**BEFORE THE BOARD OF ZONING ADJUSTMENT
OF THE DISTRICT OF COLUMBIA**

BZA Application No. 17309
Public Hearing: January 10, 2006
ANC 3D

STATEMENT OF OPPONENT
CHAIN BRIDGE ROAD/UNIVERSITY TERRACE PRESERVATION COMMITTEE

Analysis Of Tree Preservation At The Chain Bridge Road Project

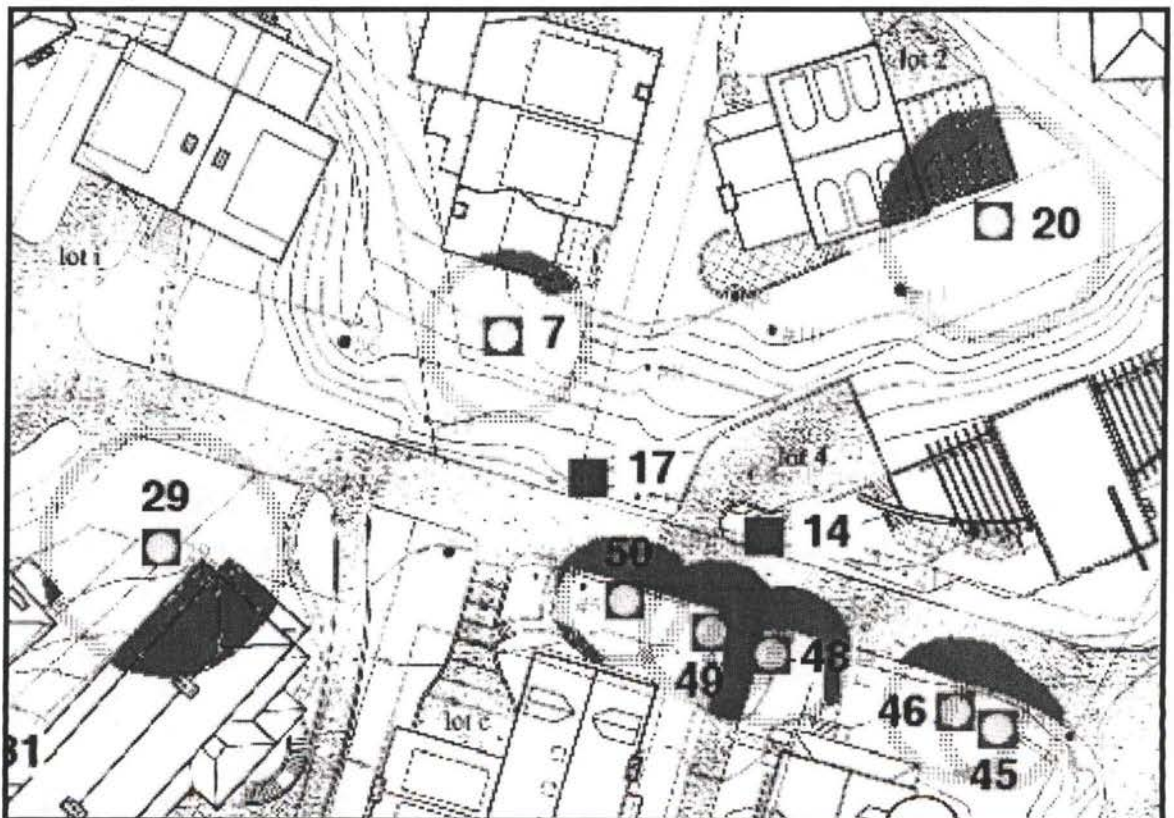
First, let's look at the *Trees Saved* plan focusing on the trees Mr. Bloch rated fifty percent or less; these are trees he stated in his July 20, 2002 letter to Mr. Bender either should be removed now (rated less than 50%), or would not tolerate construction nearby (rated 50%). The *Trees Saved* plan purports to preserve these nonviable trees.

It also is readily apparent that most of the vulnerable, construction-intolerant trees — those Mr. Bloch rated at 50% — are very close to construction. While these trees are shown on the plans as saved, it is obvious that they cannot be saved.

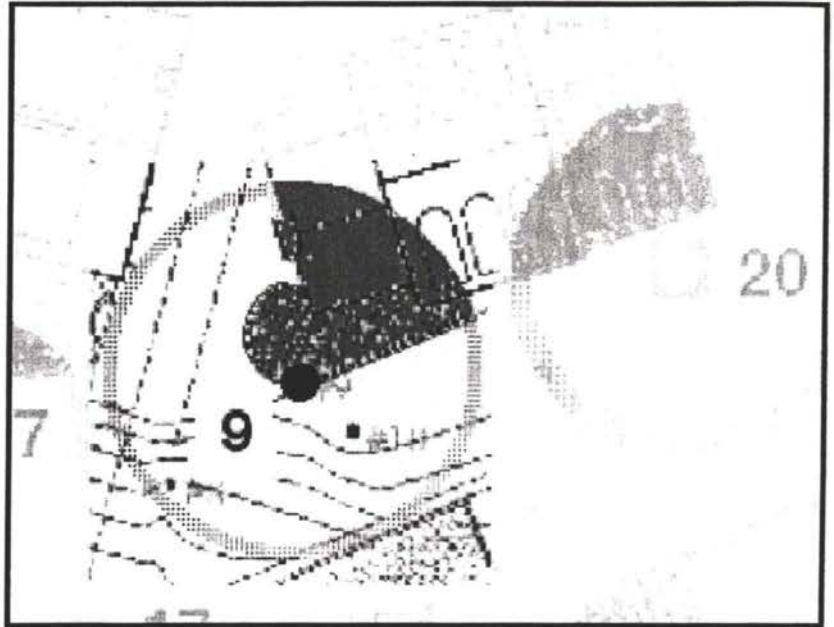
Next, let's look at a closer detail of this part of the plan. The detail below shows the entrance road. It shows only the trees rated fifty percent or less... those that Mr. Bender's arborist says should be removed now or will not tolerate construction nearby. It does not show trees that Mr. Bloch says should remain viable. The plan claims that all the trees shown here will be preserved. The solid rust colored areas are the portions of the CRZ of each tree that will be graded out if the builder manages to dig only the exact footprint of each structure. This is not possible, of course; there is always some over-dig to enable construction of foundations. In fact, only an extremely naïve person would think these huge houses

can be built without substantial grading and disruption of the trees' root zones. Certainly it will be impossible to put tree protection fencing at the drip lines of trees that stand next to houses, as the plan claims will be done. In addition, their canopies⁵ will have to be pruned substantially to fit these large houses in. This will dramatically alter the appearance of some of these trees. In the case of the beech trees, radical pruning could be destructive where large branches must be cut off.

The entrance roadway has to be widened significantly to achieve the sixteen-foot width being proposed. The plan does not show where utilities will be located, but along the entrance road is the logical place for water, sewer, and electric.

Given that the beeches are old and that this species is considered one of the most intolerant species there is, their immediate demise is inevitable if this project is carried out as planned.

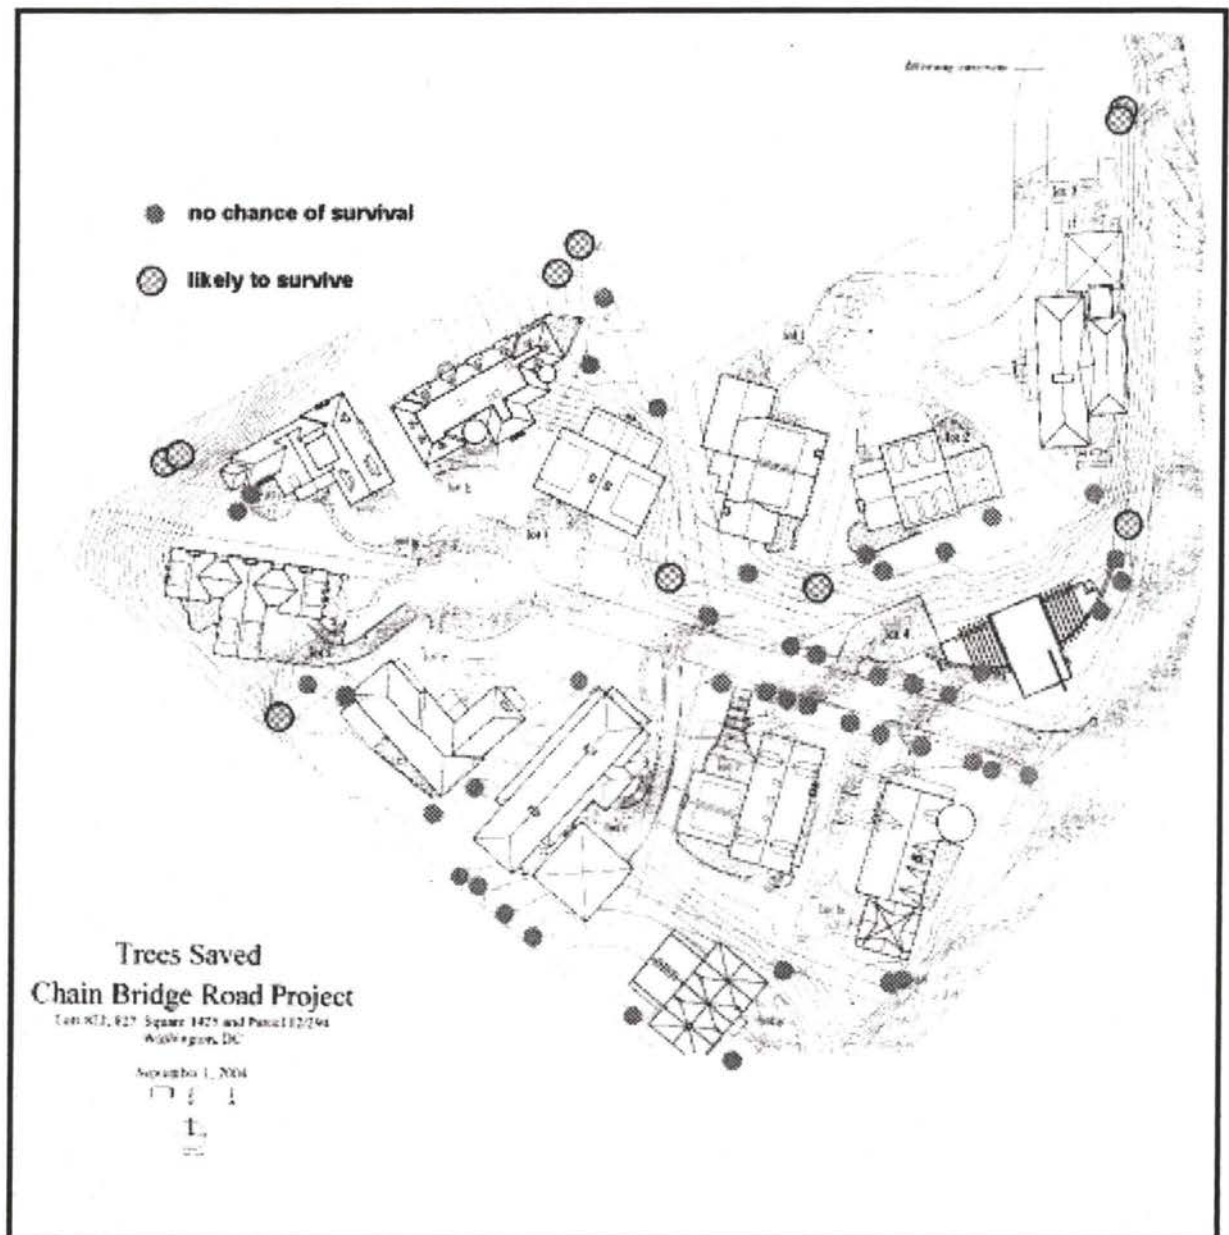
Let's take a close look at one of these highly rated trees: tree #9, a white oak (*Quercus alba*) over twenty-four inches DBH, rated seventy percent by Mr. Bloch. This detail illustrates how overly optimistic the plans for Chain Bridge Road Project are. This tree has a patio built around at least fifty percent of its base. At least one-quarter of its CRZ is lost to building and patio.

EXHIBIT 3B
VIEW TO LEFT & RIGHT FOR A DRIVER EXITING
FROM DRIVEWAY FOR #2800 CHAIN BRIDGE ROAD
Driver's Eye is Located 10 Feet from Edge of Travel Way

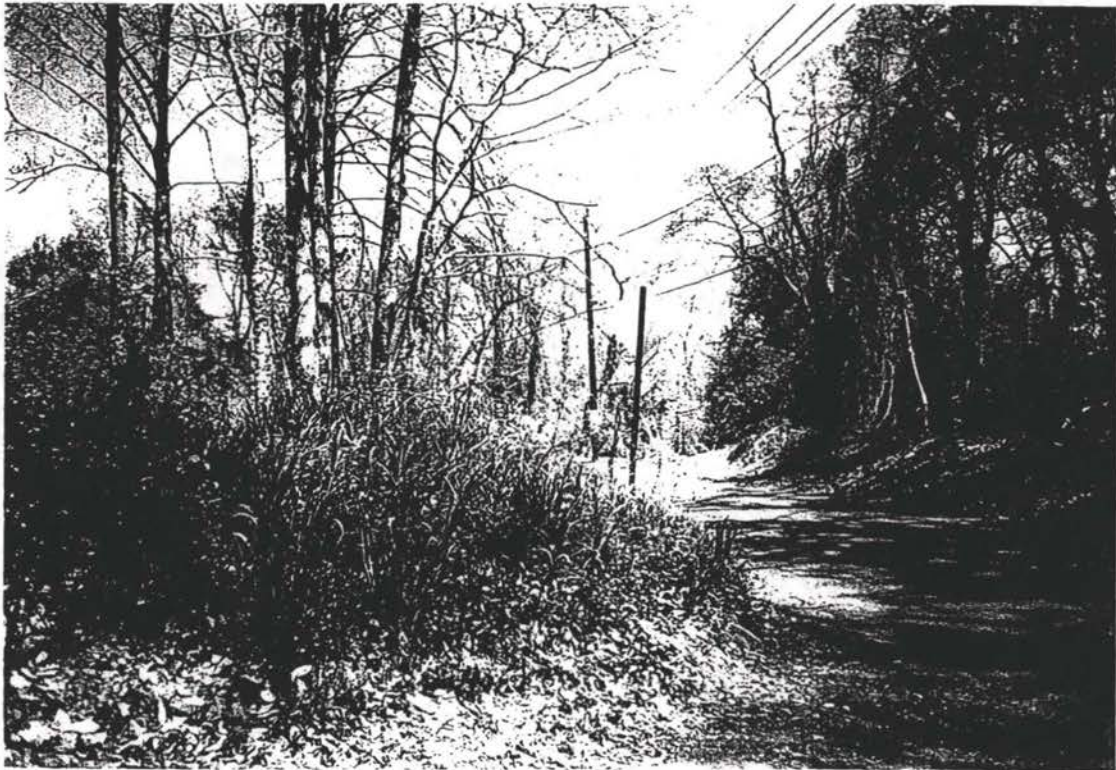
The second area that was examined was the distance that a driver exiting either of the driveways could see in each direction under current conditions or, in technical terms, the "sight distance" that was available to the driver to make a decision that it was safe to enter Chain Bridge Road via a left or right turn. To make these measurements the "eye" of the driver was placed 10 feet behind the edge of the travel way of the southbound lane of Chain Bridge Road. (Current design criteria suggest that this point should be 14 feet from the edge of the travel way but, since there is no existing sidewalk on the west side, it is anticipated a driver would pull close to the edge of the travel way.)
